Two Rivers M1998-038 Second Adequacy Response

RE: Two Rivers Pit M1998-038 Amendment Application Second Adequacy Response

Two River Pit Existing Conditions - Wells Exhibit C.3

**Two River Pit
Mining Map
Exhibit D**

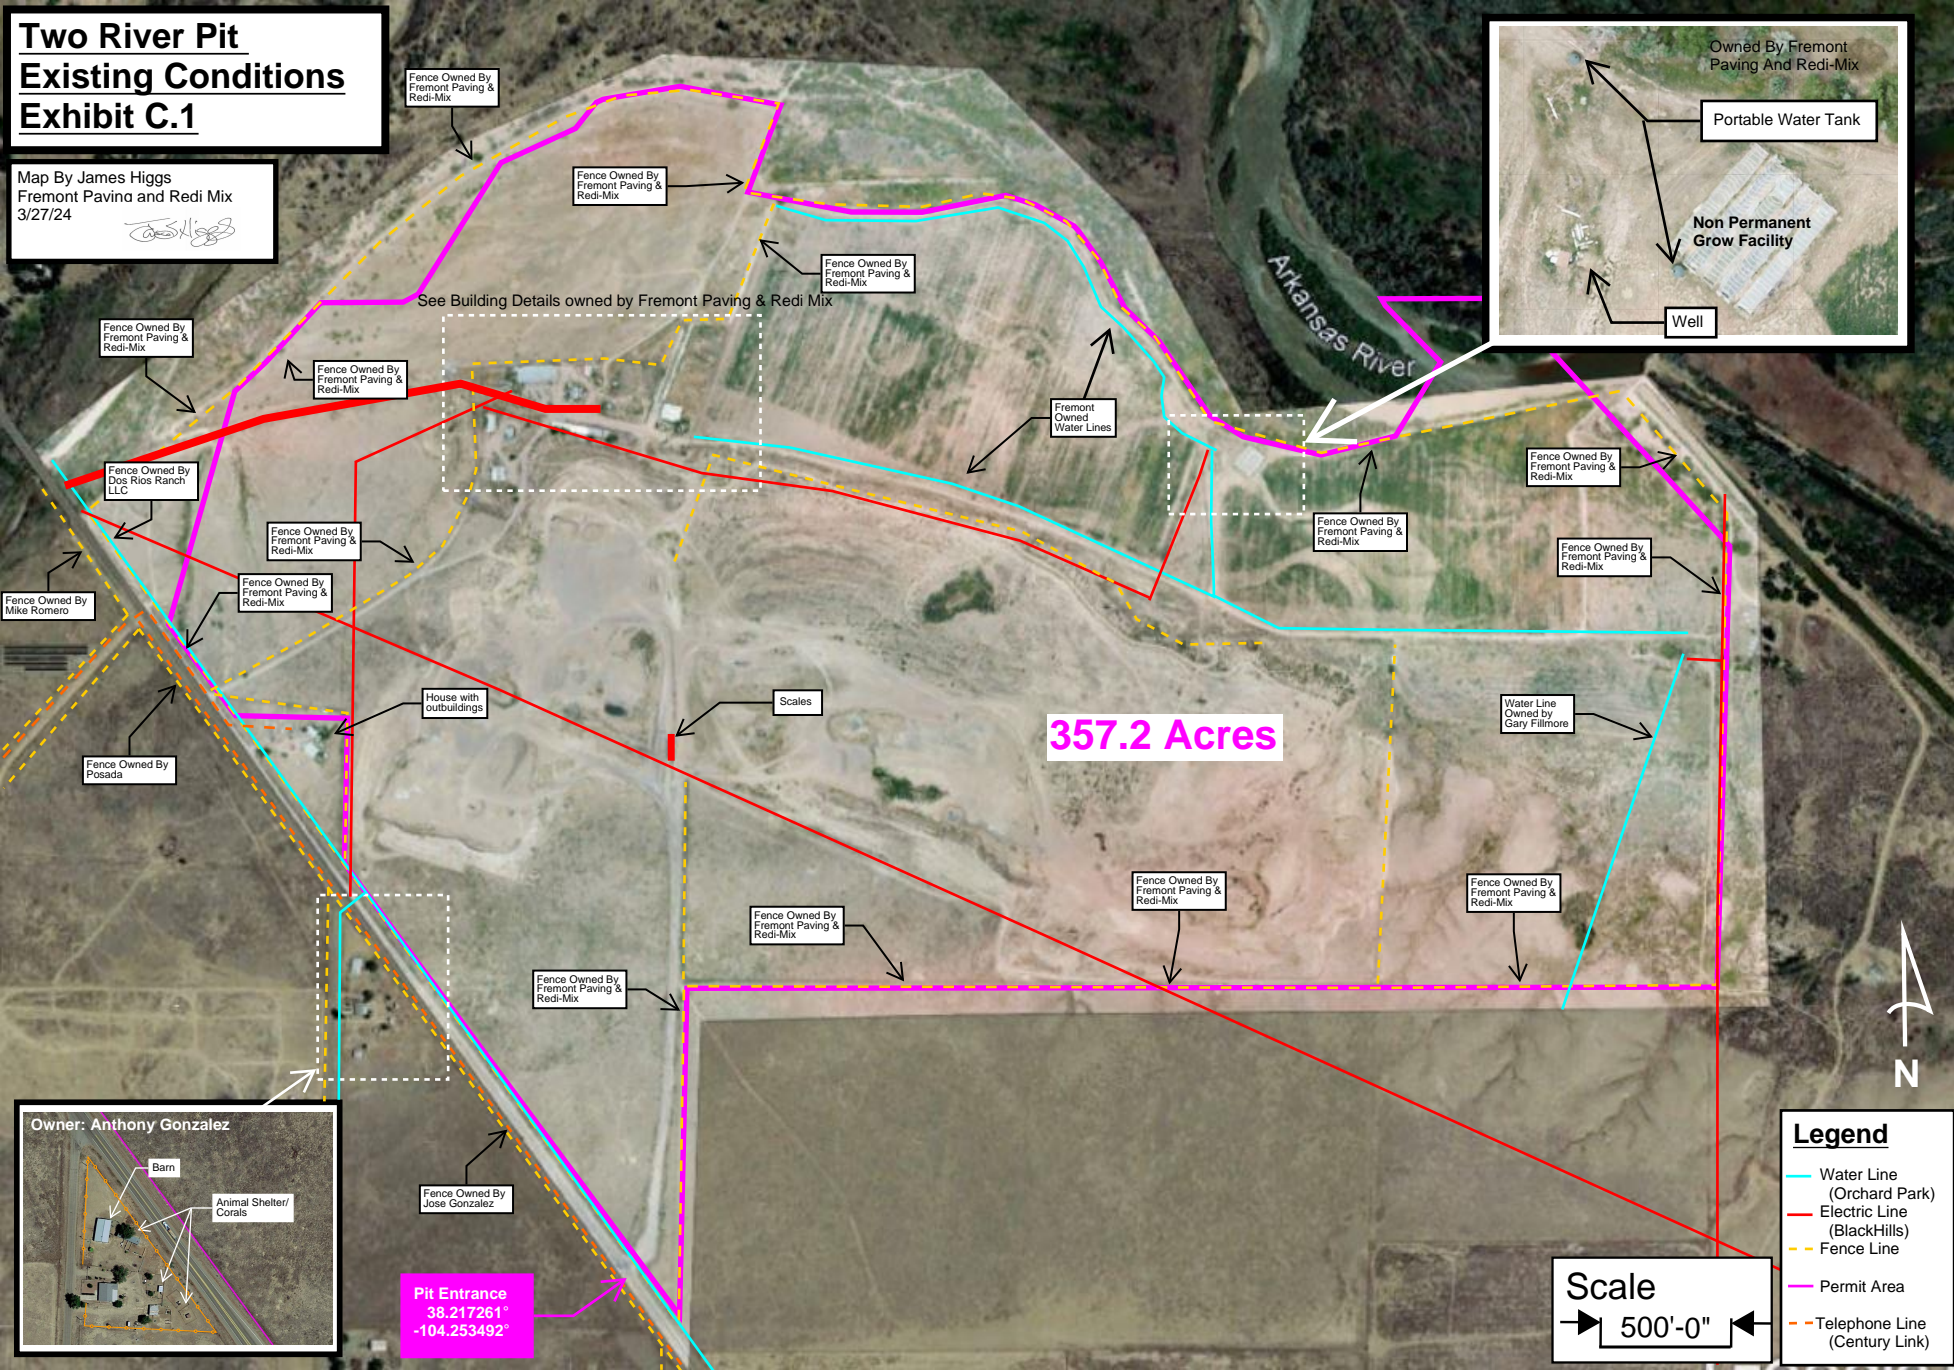
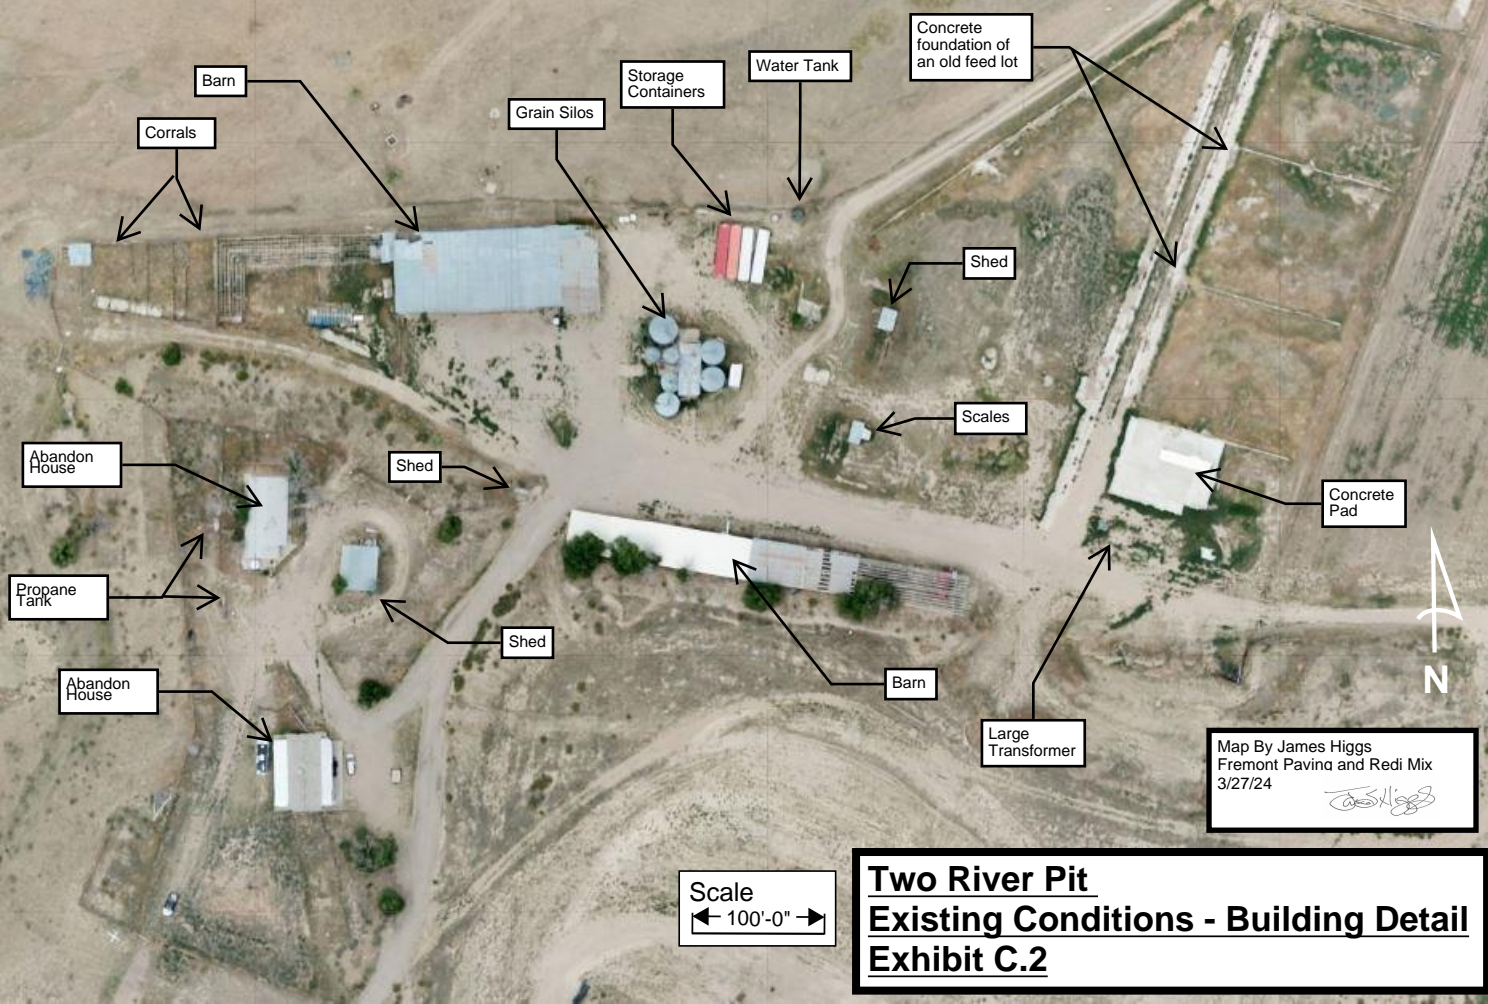
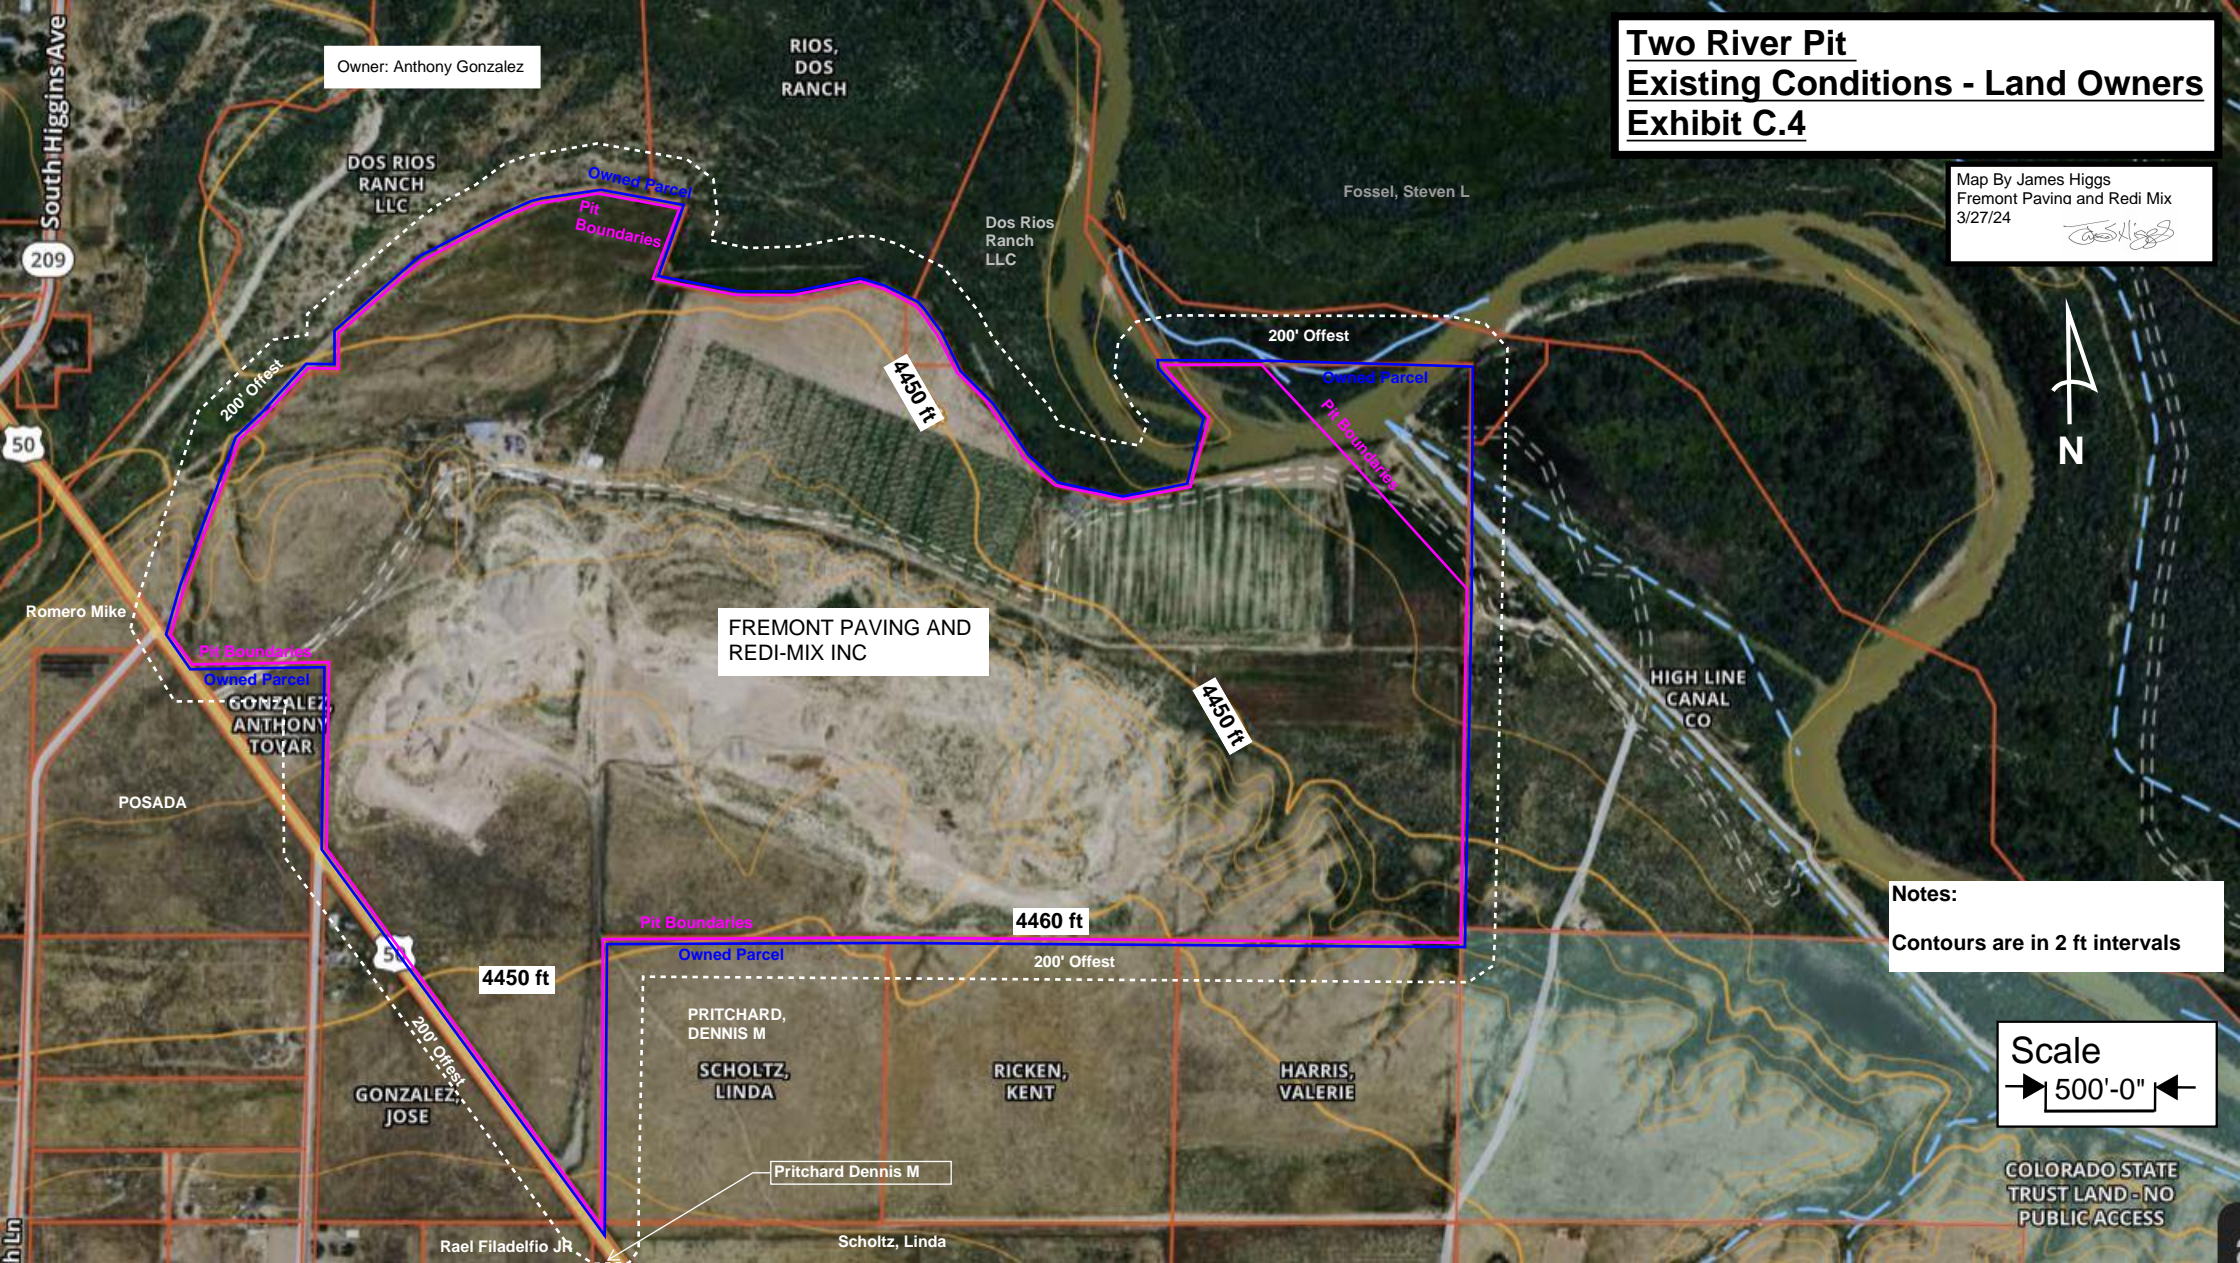
11. The trench is located at the phases that will need dewatering. Phases 1, 3, 8, 9, and 10 will not need dewatering. The trench and settling pond have been added to the Existing Conditions Map as requested, however the Rule cited I believe pertains to existing conditions and not conditions during mining activities. However, to keep this process moving forward, we have added it to satisfy the request in this review. The wash ponds are not on this map, as they will move throughout the mining process and will be in the process area.

Approximate
location of New
Settling Pond

Approximate location of
dewatering trench.

Anticipated Location of
Trench

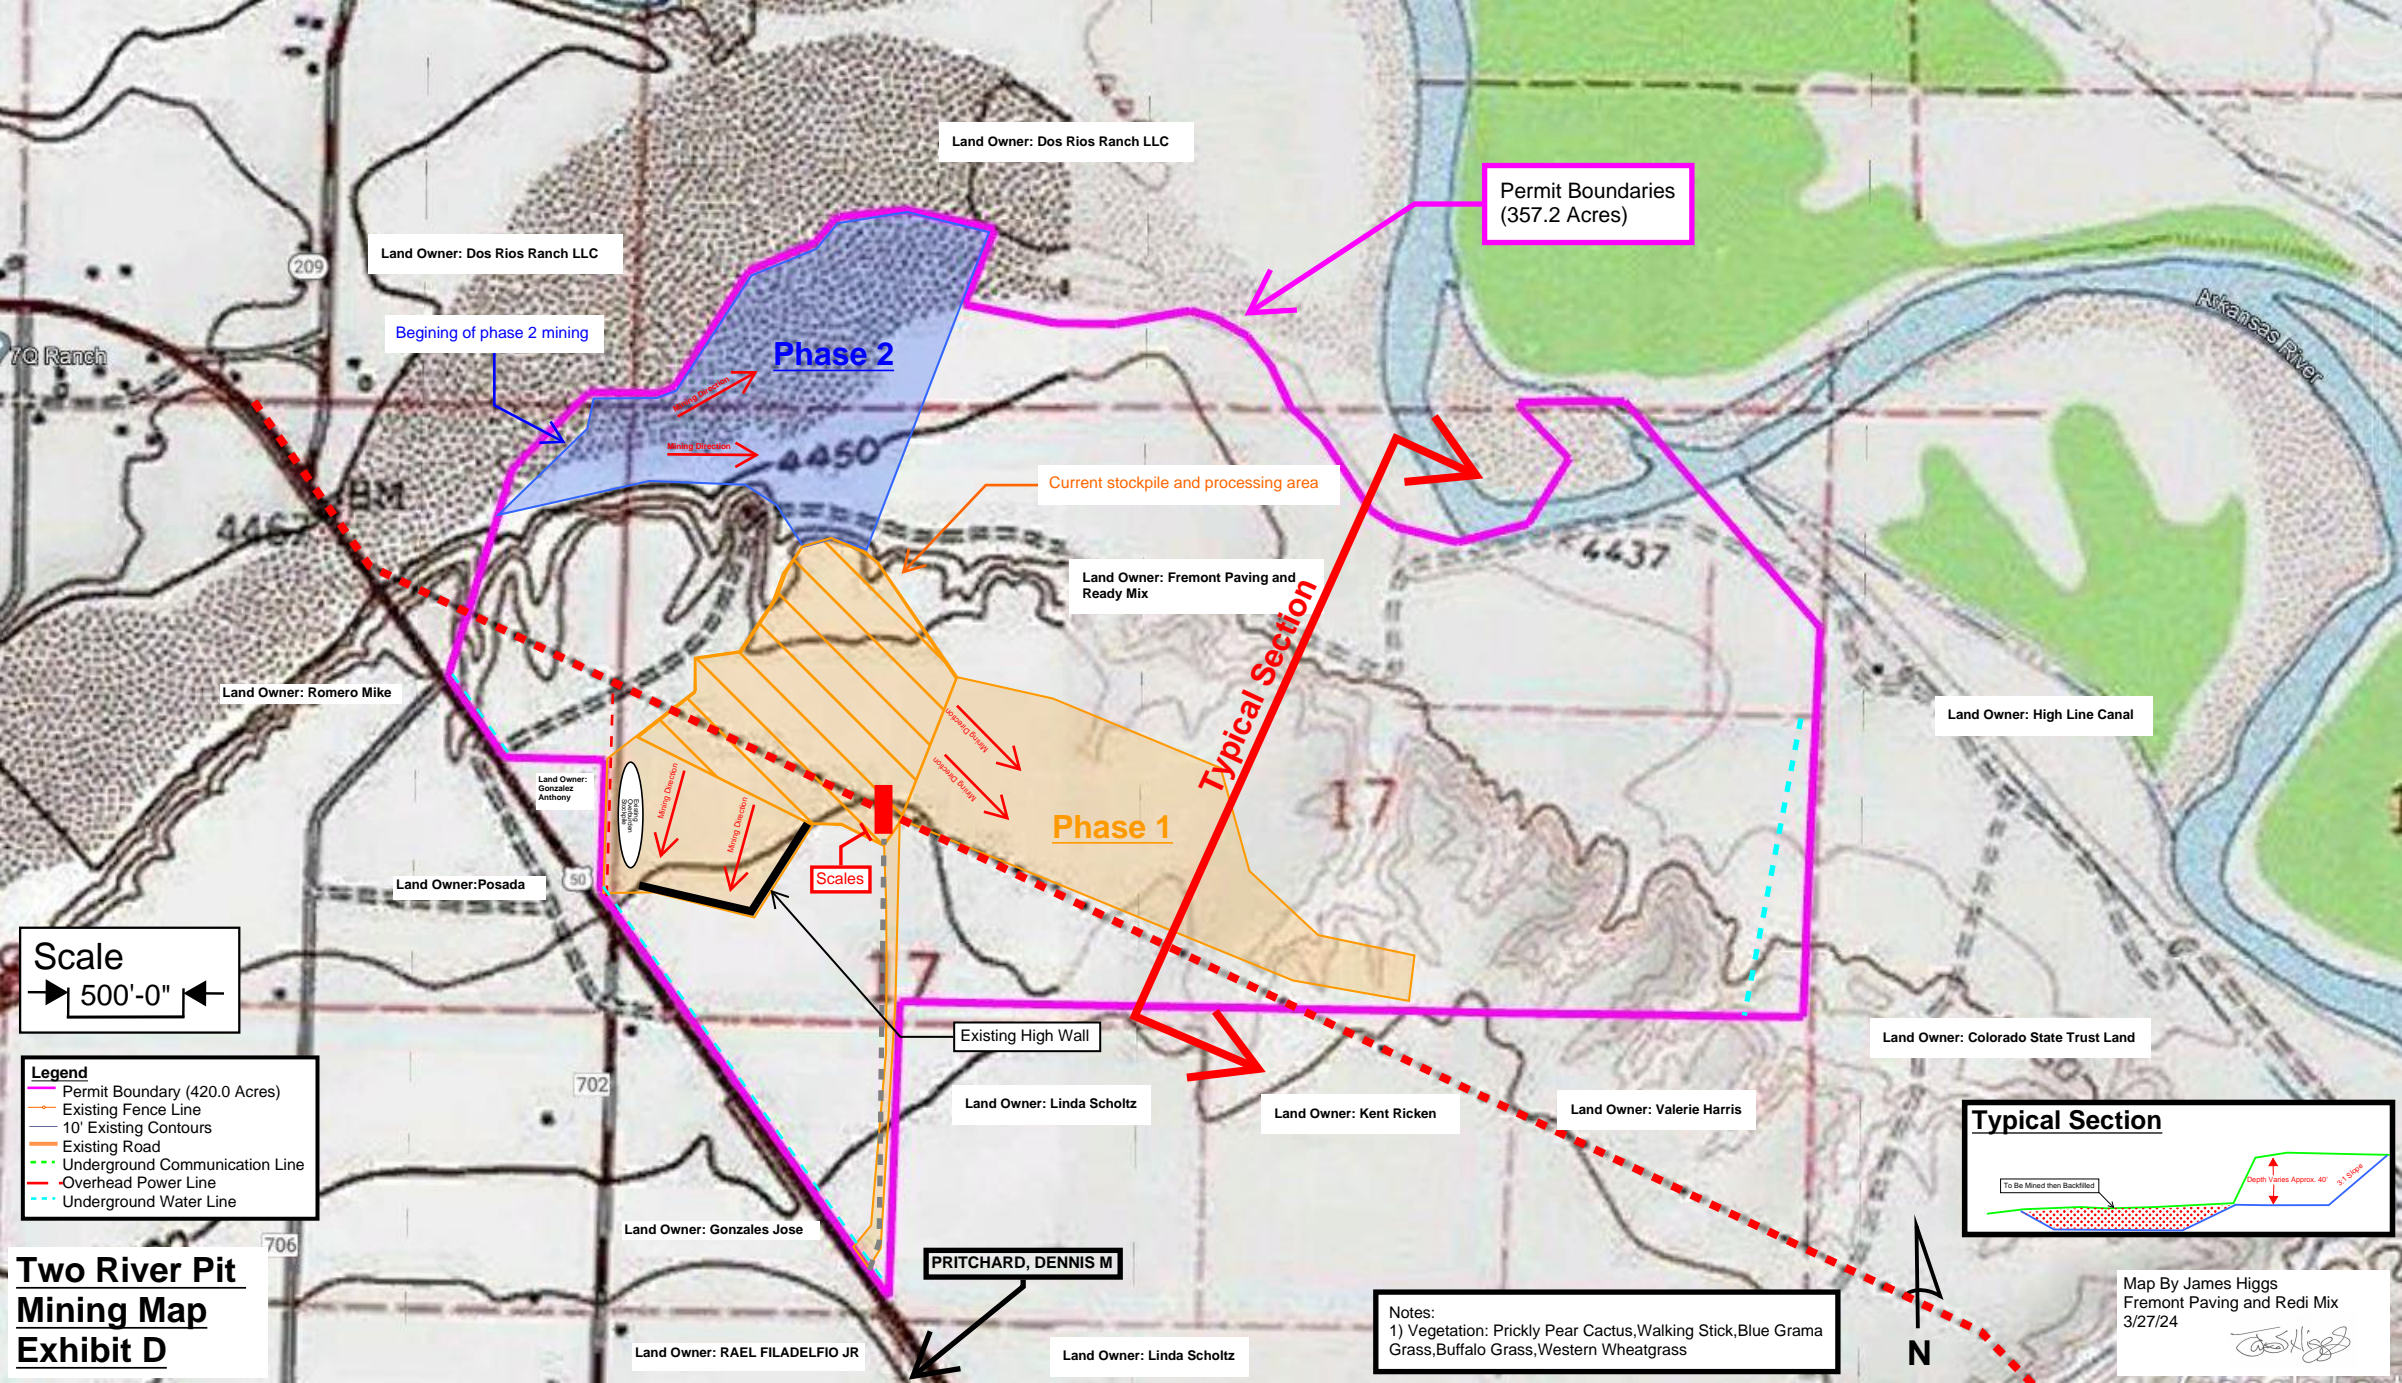
17. Please see the attached updated Mining plan with updated depths.

- 1) **Mine Phase 1 & 2**
 - a) Continue mine phase 1
 - b) Begin phase 2 by strip/stockpile overburden and topsoil.
 - c) Establish dewatering pond located north of phase 7.
 - d) Begin mining below existing ground in phase 2, (start of dewatering)
 - e) Use excess stripping, topsoil and waste material from phase 2 to backfill mined area of phase 2
 - f) As soon as feasible, start backfilling phase 2 with excess material from phase 1.
 - g) Begin reclamation process in phase 1 as mining progresses.
 - h) After enough acreage is mined and reclaimed in phase 1, begin stripping phase 3. Using this material to finish backfilling phase 2.
(never to exceed 100 acres open at any given time)
 - i) Close out majority of phase 1 (except roads and processing area)
 - j) Reclaim phase 2 as backfill is progressing.
 - g) Move mining to Phase 3 & 4

- 1) While mining there will be less than 1,000 ft at all times.
- 2) Phase time table will only driven by what the market bares. This is an estimated 5-10 years per phase.
- 3) Size and location of the dewatering ditch may change do to field conditions and changing needs of the gravel pit.
